# PSE State Diagram – Sequence 3

Considerations for Staggered Detection and Power-on of Dual-Signature PDs.

IEEE 802.3bt Task Force

Oct 2015

# CC → Det/Cls/Pwr Alt\_A/B (DS PD)

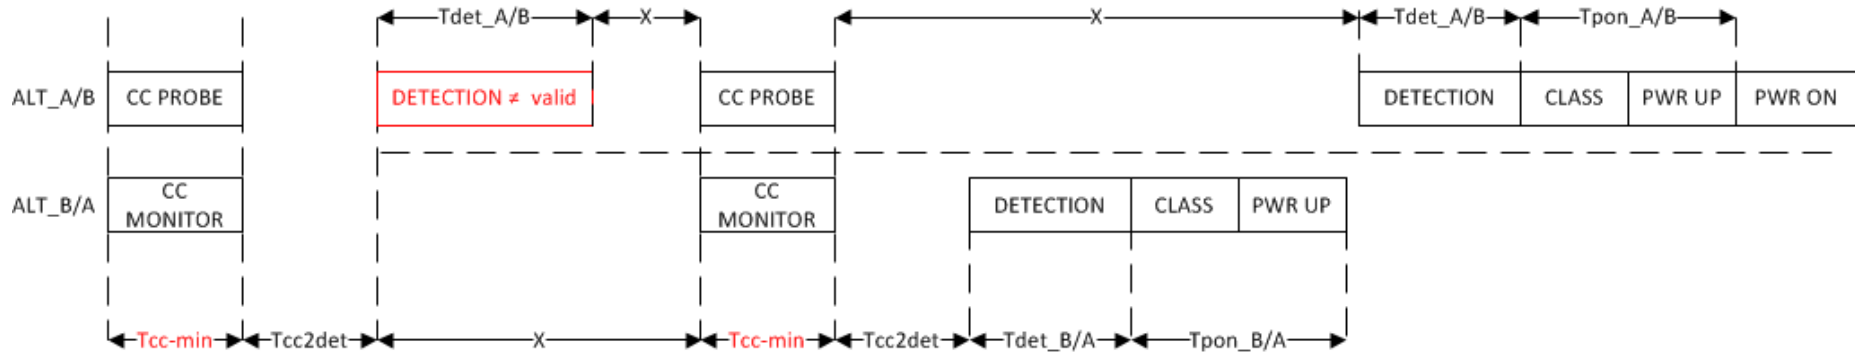
$T_{cc2det}$  is enforced for the first pairset to successfully power.

$T_{det}$  and  $T_{pon}$  are enforced for each pairset.

# Alternative A/B Parity:

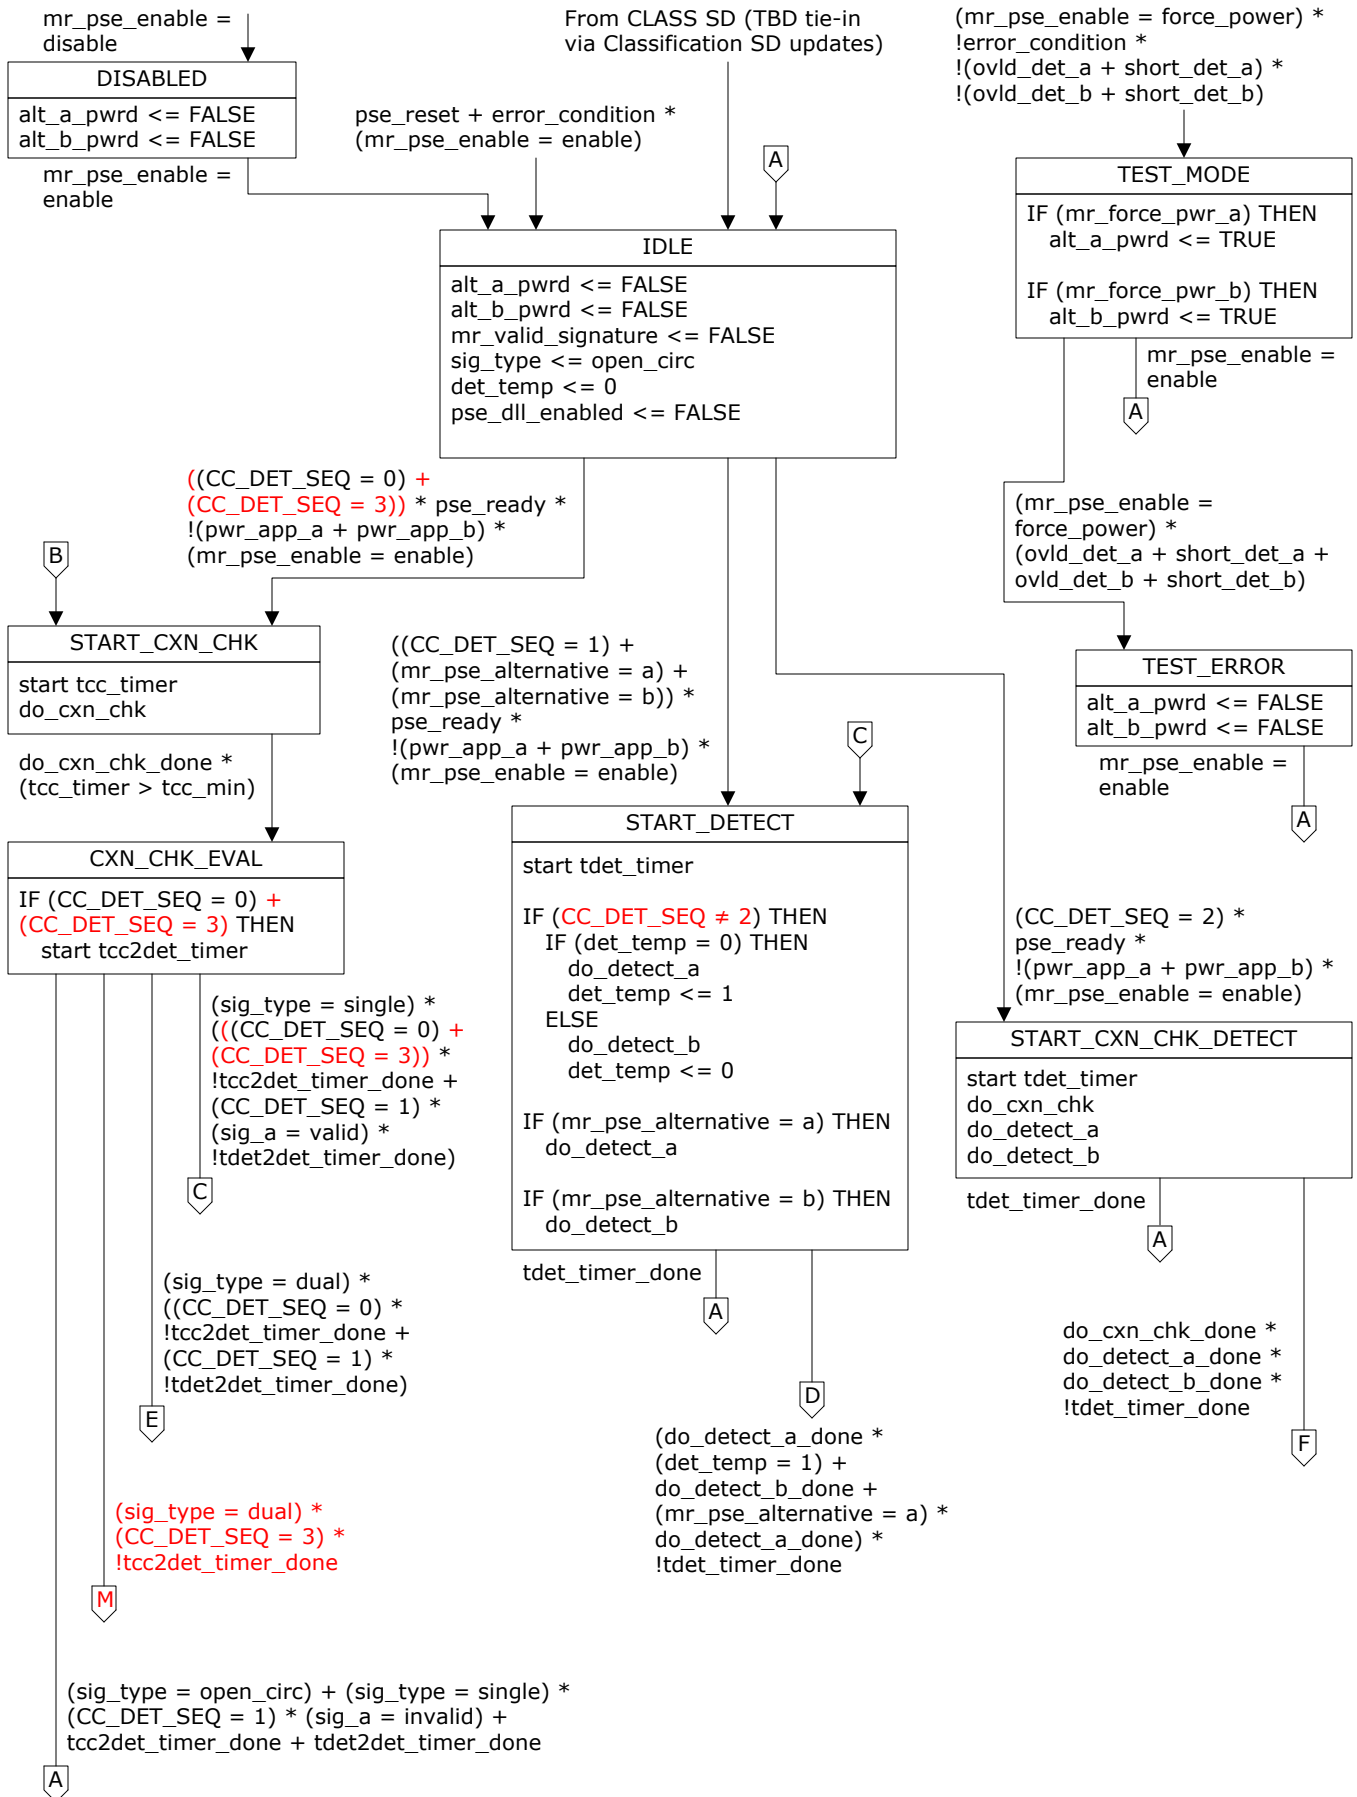
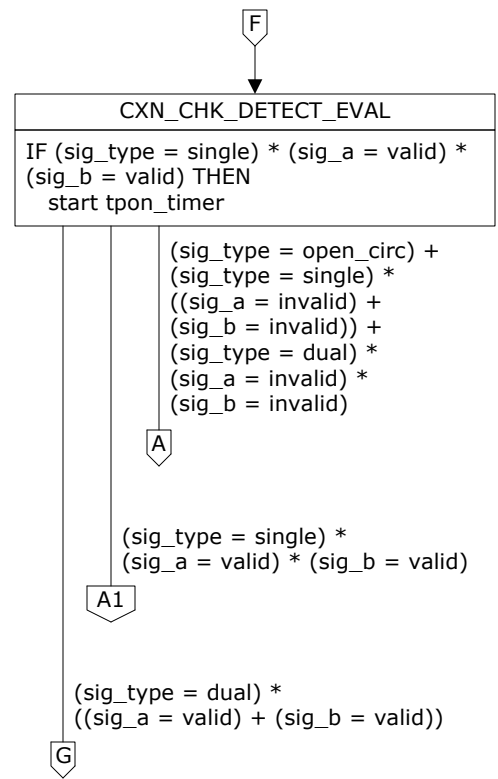
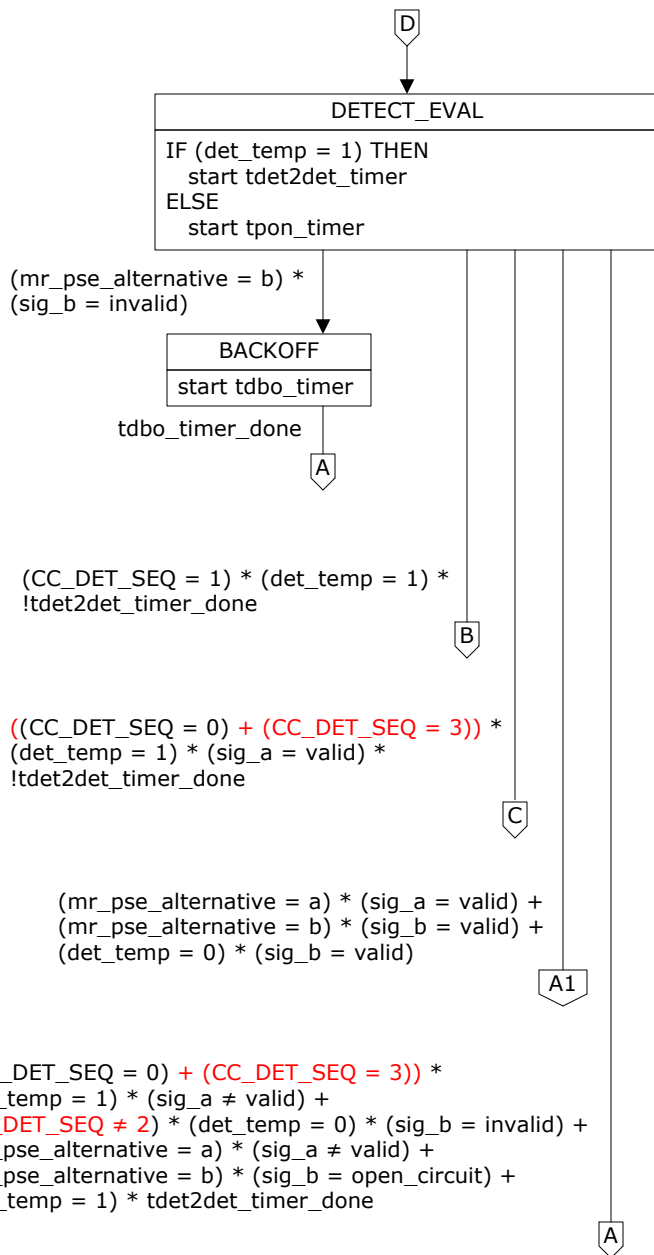
Treatment of Alt-A and Alt-B are interchangeable for the purposes of the State Diagram

# Alternative A/B Parity text:

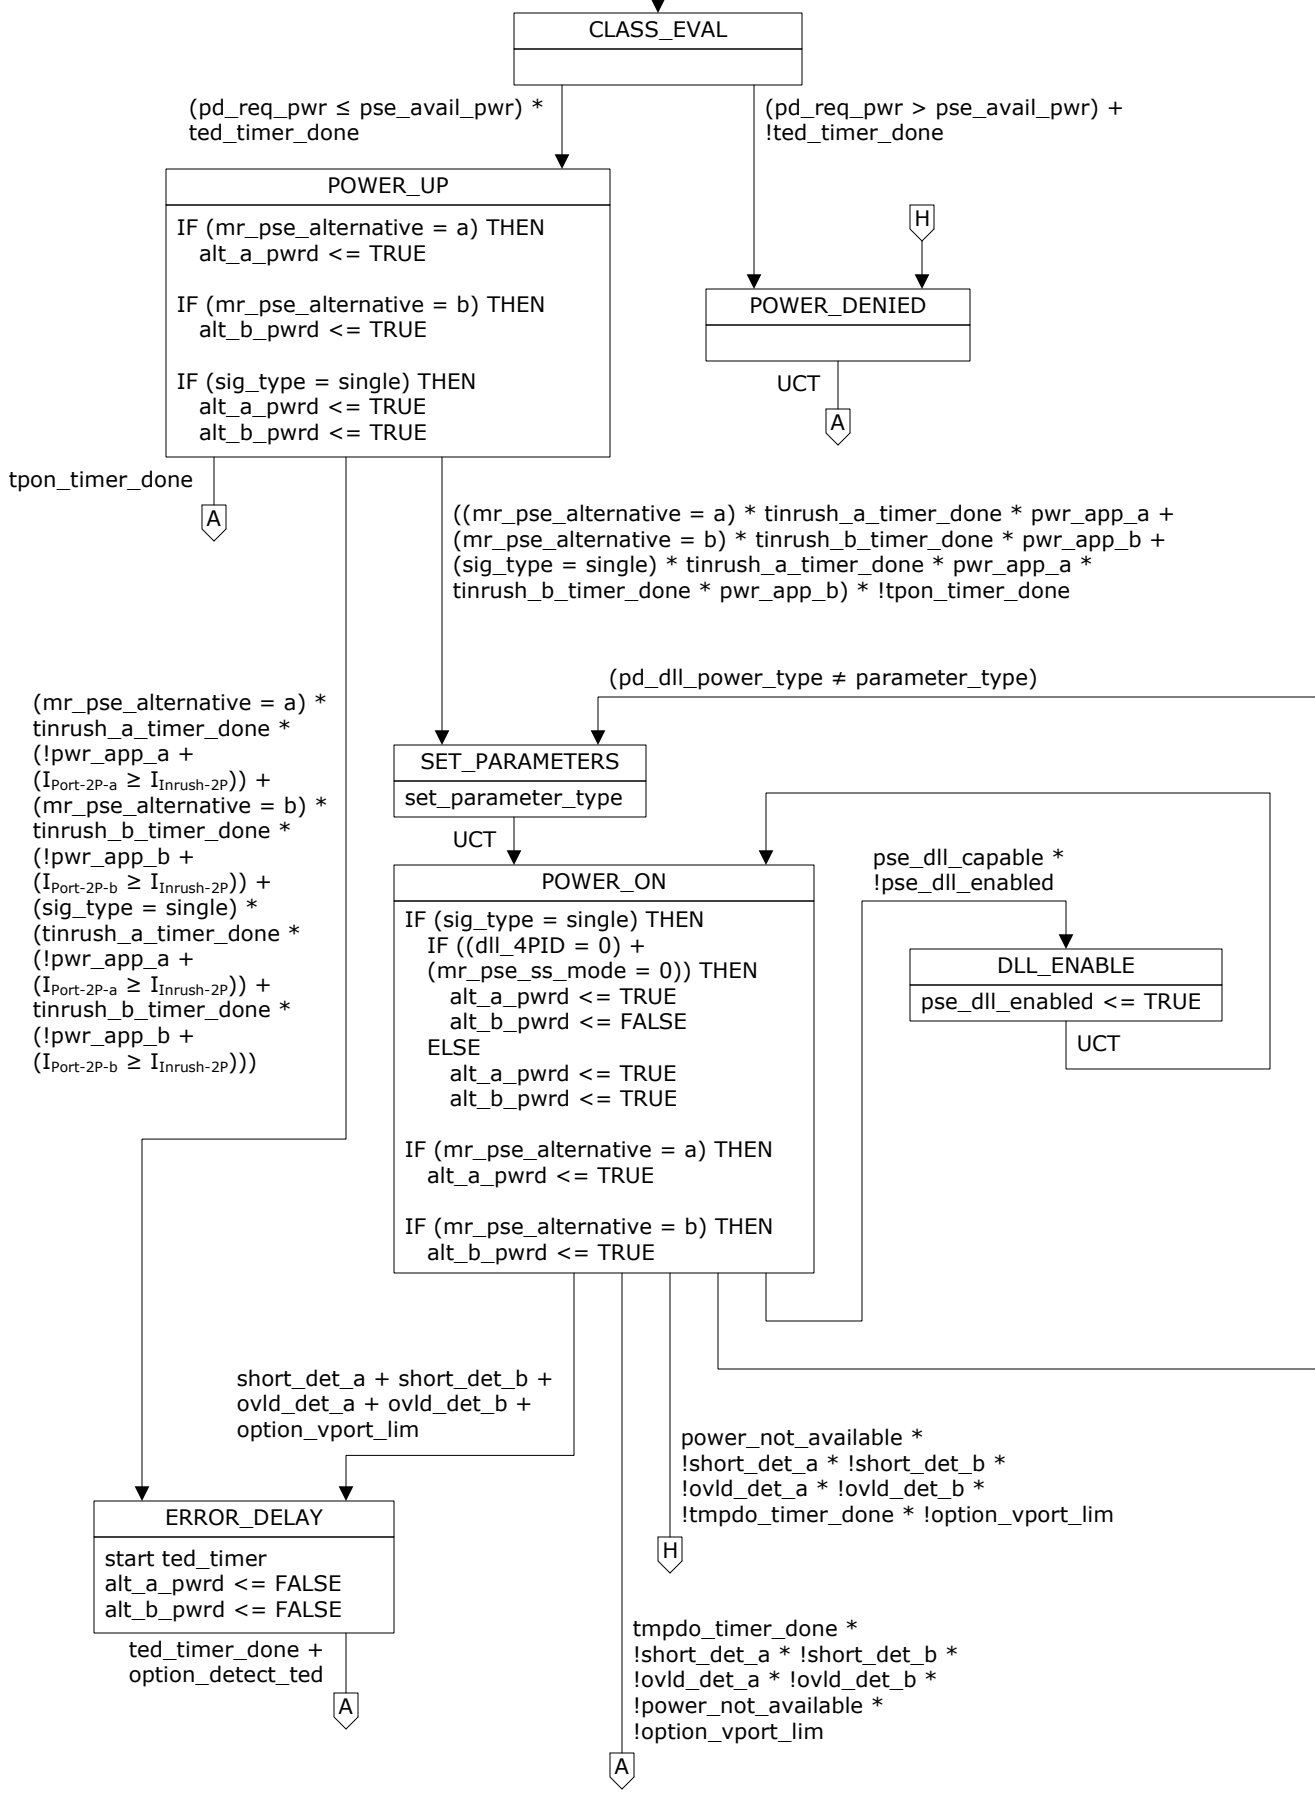
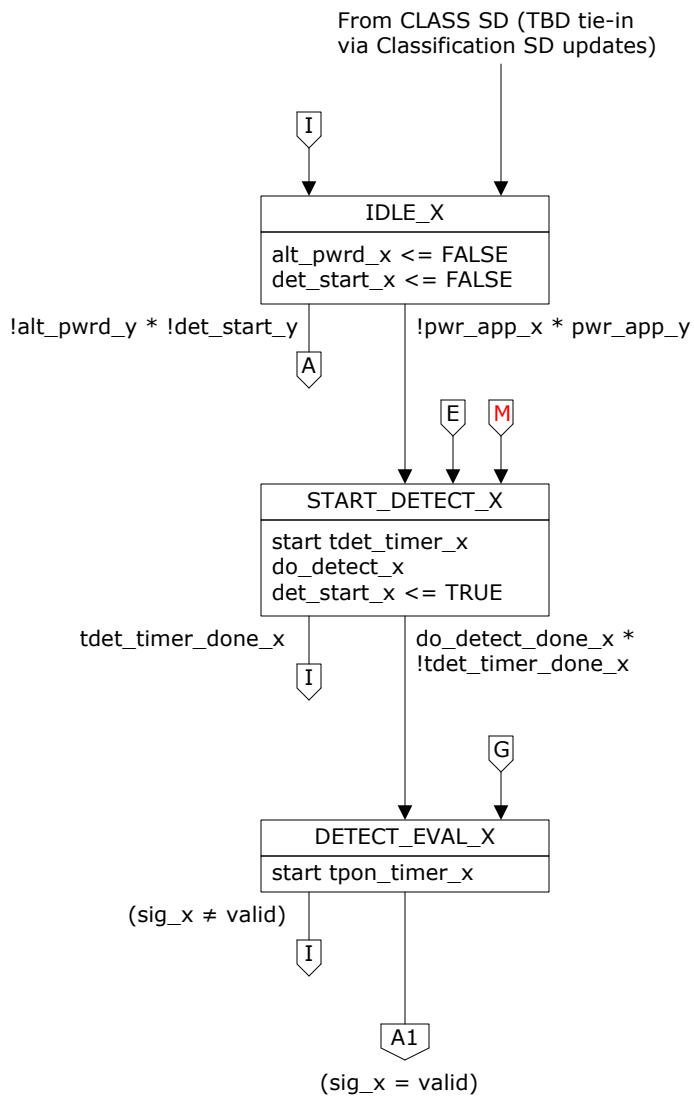
Add the following text in section 33.2.4.1:

“In the Type 3 and Type 4 state diagram, Alternative A and Alternative B are depicted as serving distinct roles during 4-pair operation. In any implementation, the behaviors of the Alternatives may be reversed as long as the roles are established in IDLE and shall be maintained in every other state.”
